File: 38050-03/ Nicola Valley Aggregates

March 31, 2021

From: David Thomson, P.Geo., Regional Hydrogeologist
Ministry of Forests, Lands, Natural Resource Operations & Rural Development
South Area Groundwater Science, Vernon, BC.
David.Thomson@gov.bc.ca

Re: Review of Active Earth Engineering Ltd (Active Earth) Reports: “Revised Hydrogeological Study” and “Preliminary Hydrogeological Study Response”

Figure 1: Water wells in the vicinity of the site, accessed from GWELLS on September 14, 2020

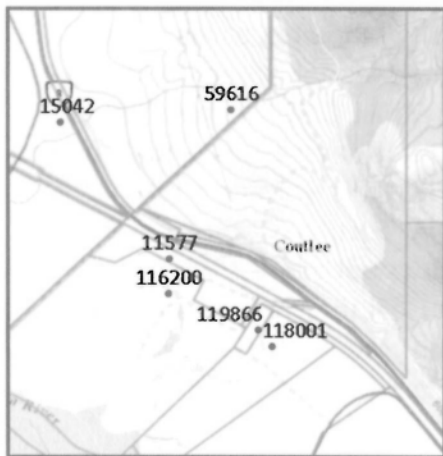
The bolding above indicates the key missing information in the Reports. The apparent down slope users have not been field-verified, as recommended above, so the degree of hydrogeological study required is not apparent. Figure 1 from FLNRORD's earlier 2020 response, and reproduced below, indicates existing water wells of interest that are available to review from a desktop analysis as well as a field visit. In the absence of this knowledge it is difficult to design appropriate site-specific mitigative measures. More specifically, it is best practice for aggregate operators to design site-specific measures in regards to groundwater protection, then additional site-specific information about groundwater is required relative to these downslope users.

With respect to the downgradient private wells (shown in Figure 1 but not necessarily limited to those), FLNRORD restate their previous comment:

Figure 1: Water wells in the vicinity of the site, accessed from GWELLS on September 14, 2020

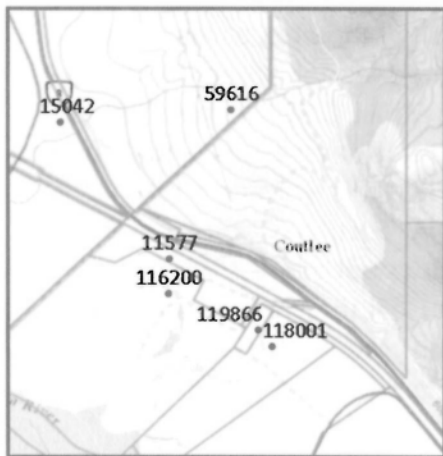
The bolding above indicates the key missing information in the Reports. The apparent down slope users have not been field-verified, as recommended above, so the degree of hydrogeological study required is not apparent. Figure 1 from FLNRORD's earlier 2020 response, and reproduced below, indicates existing water wells of interest that are available to review from a desktop analysis as well as a field visit. In the absence of this knowledge it is difficult to design appropriate site-specific mitigative measures. More specifically, it is best practice for aggregate operators to design site-specific measures in regards to groundwater protection, then additional site-specific information about groundwater is required relative to these downslope users.

With respect to the downgradient private wells (shown in Figure 1 but not necessarily limited to those), FLNRORD restate their previous comment:

CLIENT NAME: NICOLA VALLEY AGGREGATES		PROJECT LOCATION: MERRITT, BC	
SITE PLAN (CONTOUR & AQUIFER MAP) 701 HIGHWAY 8			
DWN BY: EB/GM	DWG NAME: -2	DATE: 2019-04-05	FIGURE 2
CHK'D: DK	PLOT:	CADFILE: 1887

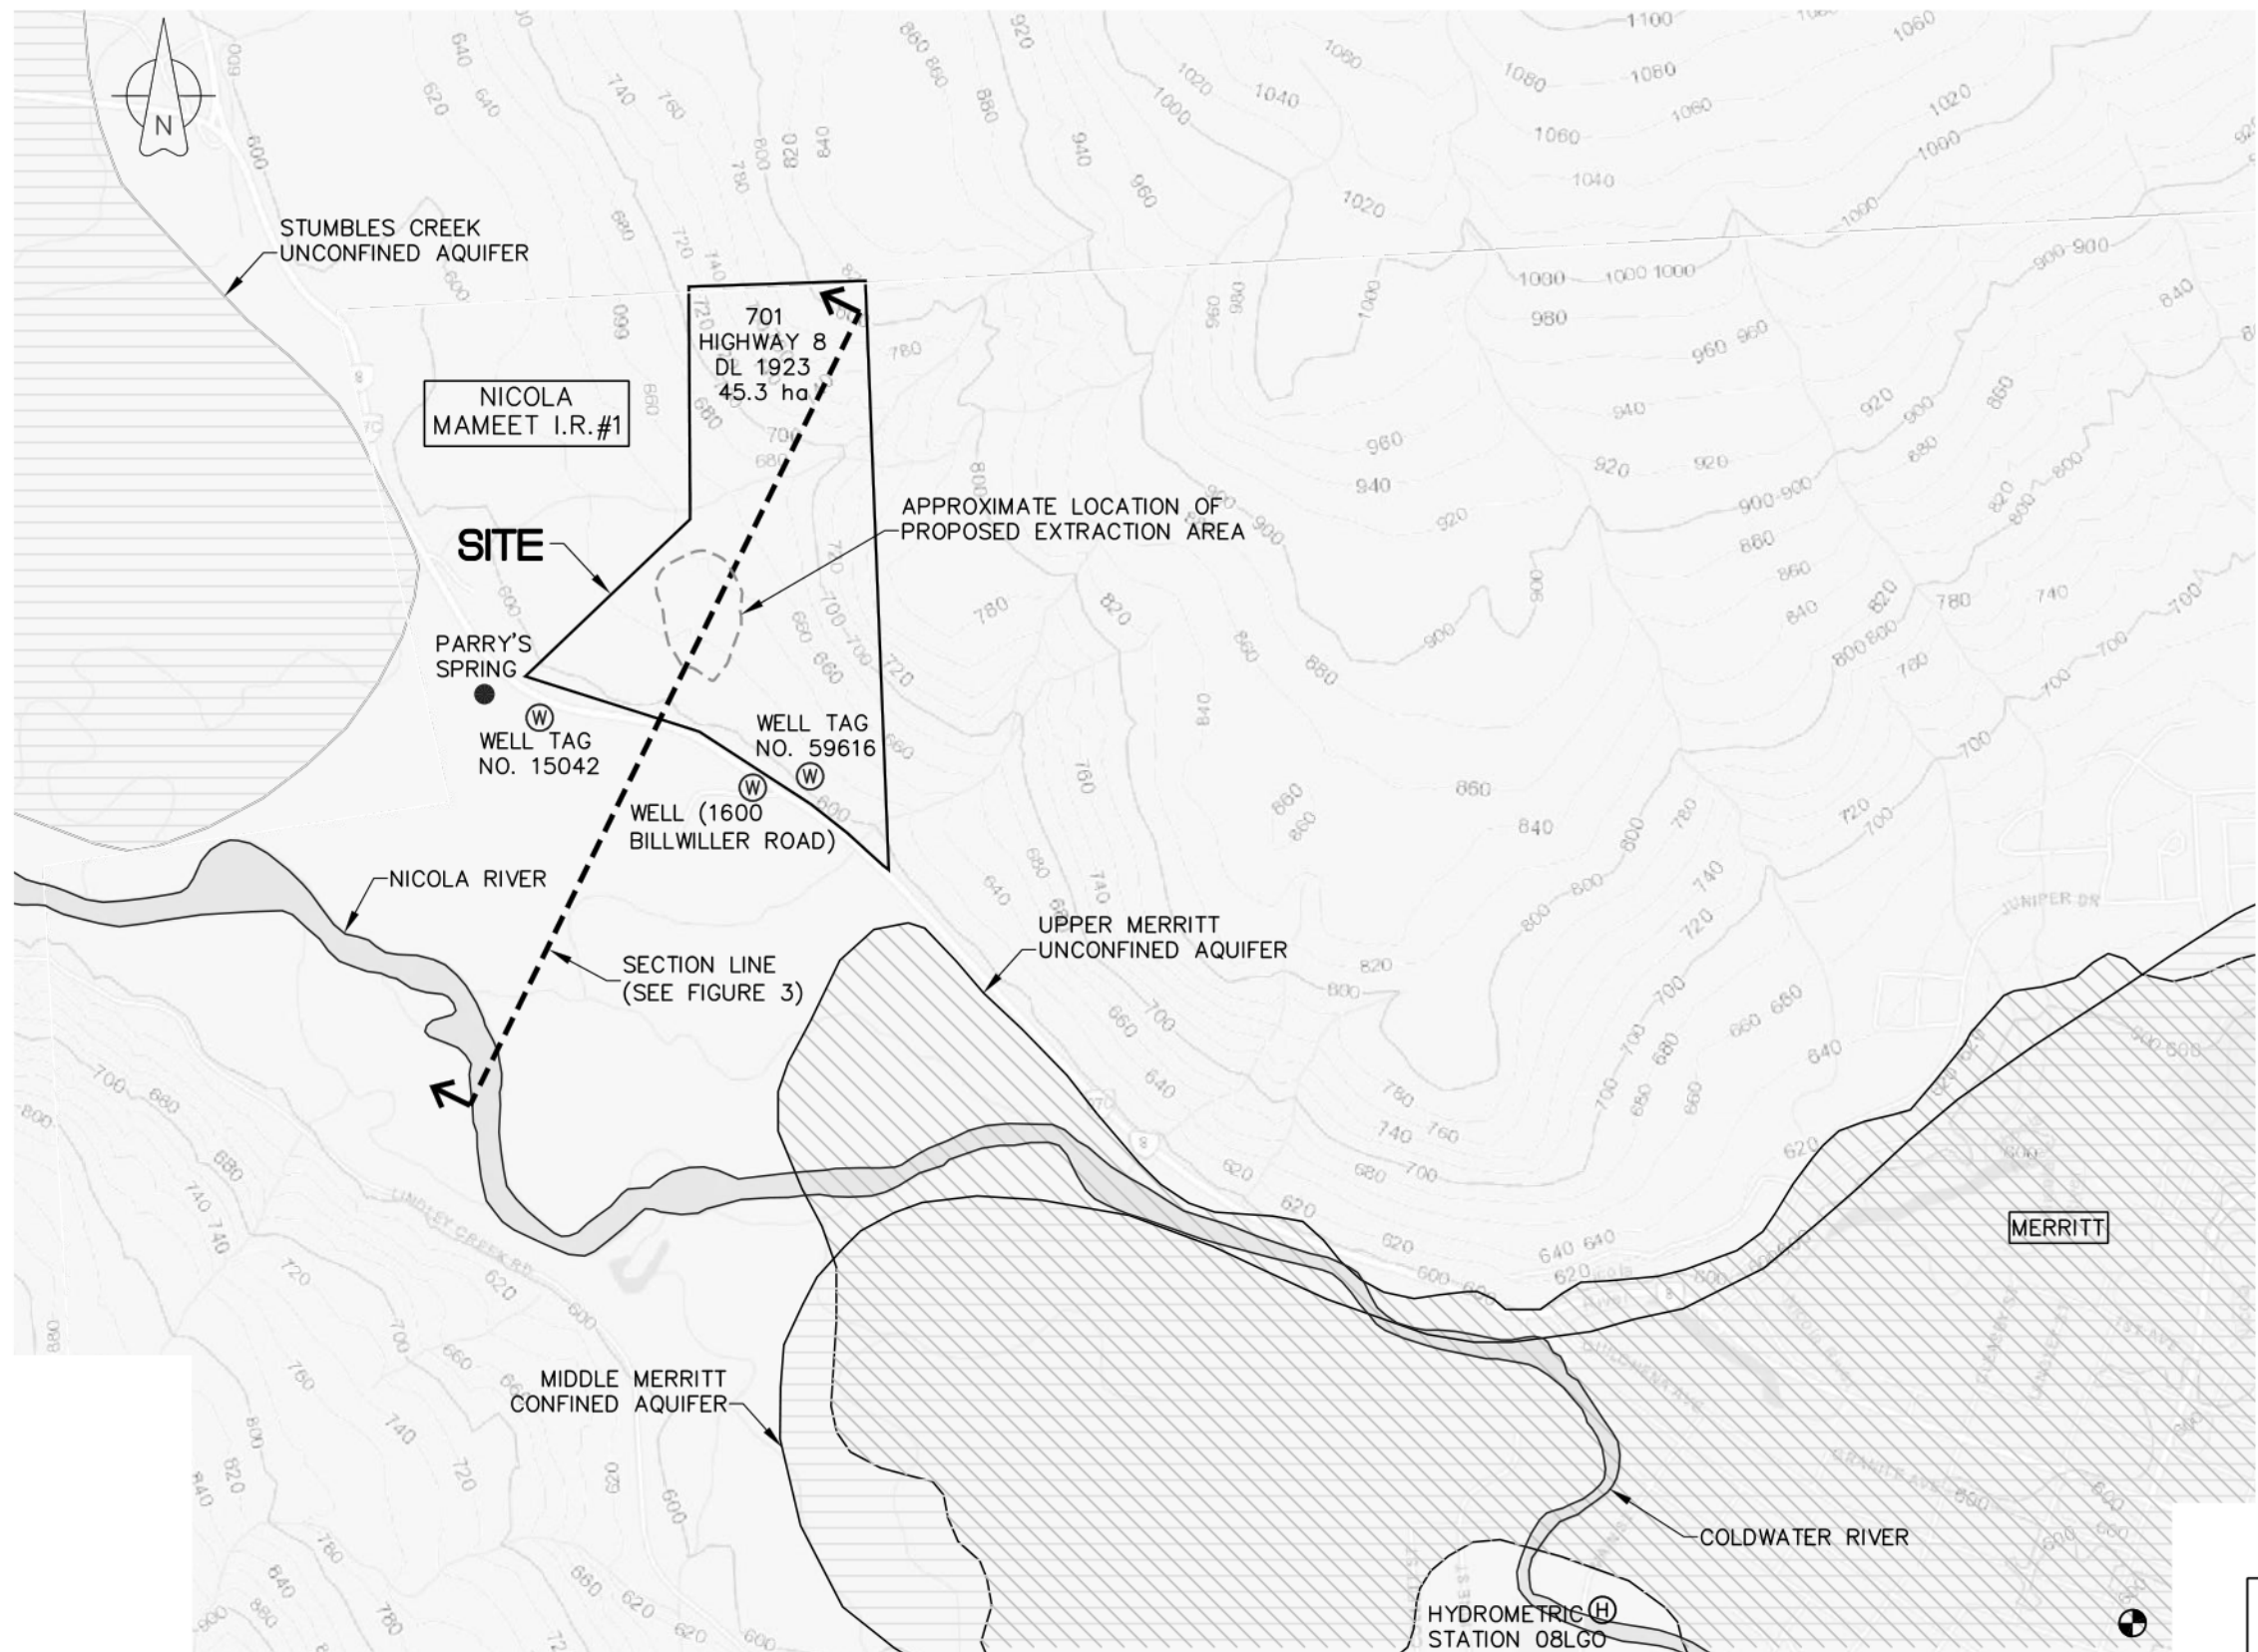
- FLNRORD noted that WTN 11577 is not present in the report. Please note that Figure 2 shows the most relevant wells as a result of ground truthing. It is common knowledge that old wells are not plotted correctly simply because they were located by legal description. We are aware that groundwater levels are shallower in the valley below Highway 8

It is important to note first that while Figure 2 (Active Earth, 2019) has correctly identified Aquifer 74 as unconfined, the shading does not match the legend. This could lead the reader to believe there is not an unconfined aquifer on the other side of the proposed development. This

FIGURE 3

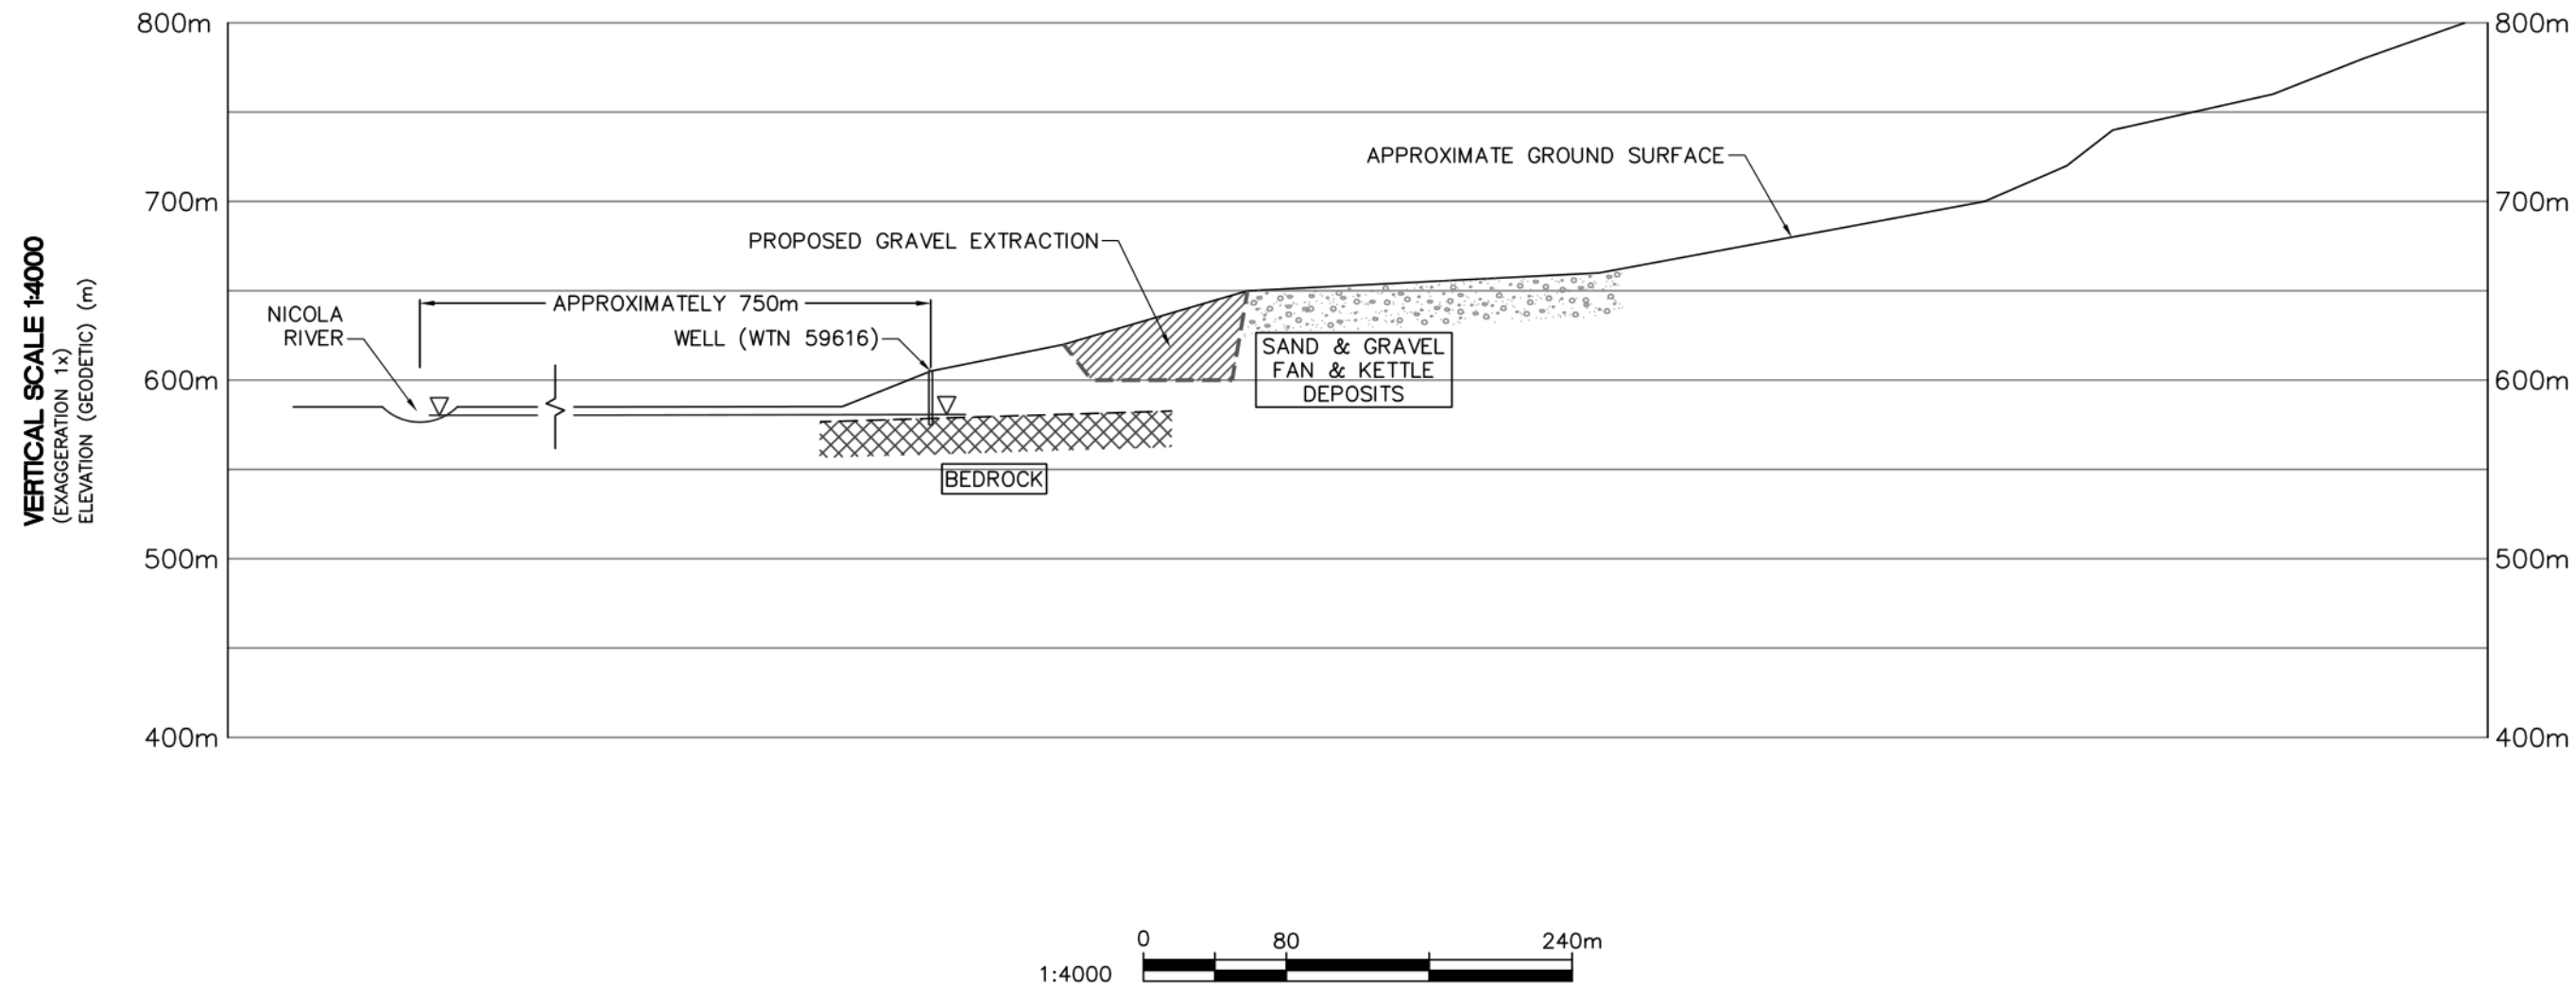
- b. The Conceptual Hydrogeological Section (Figure 3) shows shallow dipping bedrock and an assumed depth to bedrock beneath the proposed gravel pit. This has not been proven at this location and should be established by drilling and installing a monitoring well at the quarry.*

Figure 1: Water wells in the vicinity of the site, accessed from GWELLS on September 14, 2020

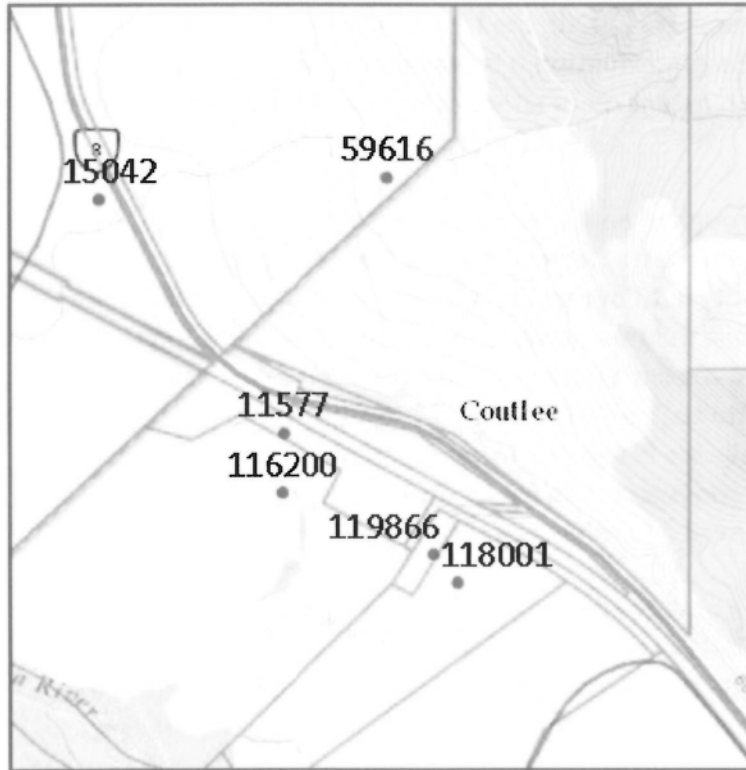
When accessed September 14, 2020, the GWELLS database showed 4 registered wells south of the site as shown in the screenshot below (Figure 1). Figure 2 (Active Earth, 2019) shows only three wells to be considered as part of the review; WTN 59616 is shown to exist south of the property, but the GWELLS database (accessed September 14, 2020) shows it to be present immediately west of the property. This well record is assigned to Aquifer 725, which is present approximately 10 km west of the site. WTN 15042 is shown in Active Earth's Figure 2 to be immediately south of the southwest property boundary, in contrast to online mapping that places it to the north west.

WTN 11577 is not present in Active Earth's report, but if located correctly in online mapping indicates groundwater at eight feet below the ground surface. This and other well information noted above needs to be reconciled and incorporated into a more detailed hydrogeological report, and should better inform a revised subsurface cross-section.

Figure 1: Water wells in the vicinity of the site, accessed from GWELLS on September 14, 2020

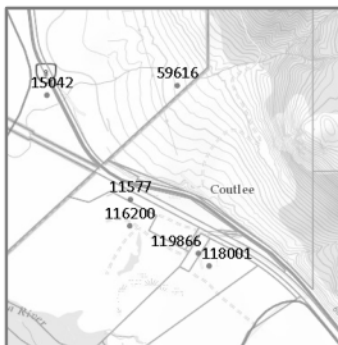
The bolding above indicates the key missing information in the Reports. The apparent down slope users have not been field-verified, as recommended above, so the degree of hydrogeological study required is not apparent. Figure 1 from FLNRORD's earlier 2020 response, and reproduced below, indicates existing water wells of interest that are available to review from a desktop analysis as well as a field visit. In the absence of this knowledge it is difficult to design appropriate site-specific mitigative measures. More specifically, it is best practice for aggregate operators to design site-specific measures in regards to groundwater protection, then additional site-specific information about groundwater is required relative to these downslope users.

With respect to the downgradient private wells (shown in Figure 1 but not necessarily limited to those), FLNRORD restate their previous comment:

Figure 1: Water wells in the vicinity of the site, accessed from GWELLS on September 14, 2020

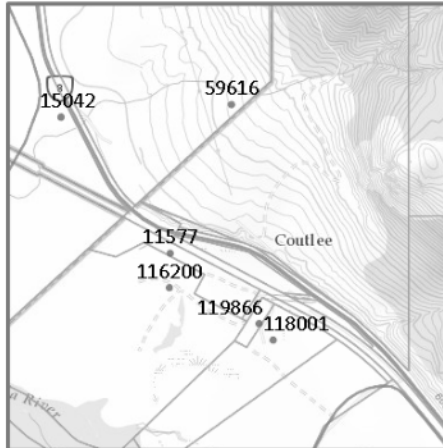
The bolding indicates the key missing information. The apparent down slope users have not been field-verified, so the degree of hydrogeological study required is not apparent. Figure 1 from FLNRORD's response earlier, and reproduced below, indicates existing water wells of interest that are available to review from a desktop analysis as well as a field visit. In the absence of this knowledge it is difficult to design appropriate site-specific mitigative measures. More specifically, it is best practice for aggregate operators to design site-specific measures in regards to groundwater protection, then additional site-specific information about groundwater is required relative to these downslope users.

With respect to the downgradient private wells (shown in Figure 1 but not necessarily limited to those), FLNRORD restate their previous comment:
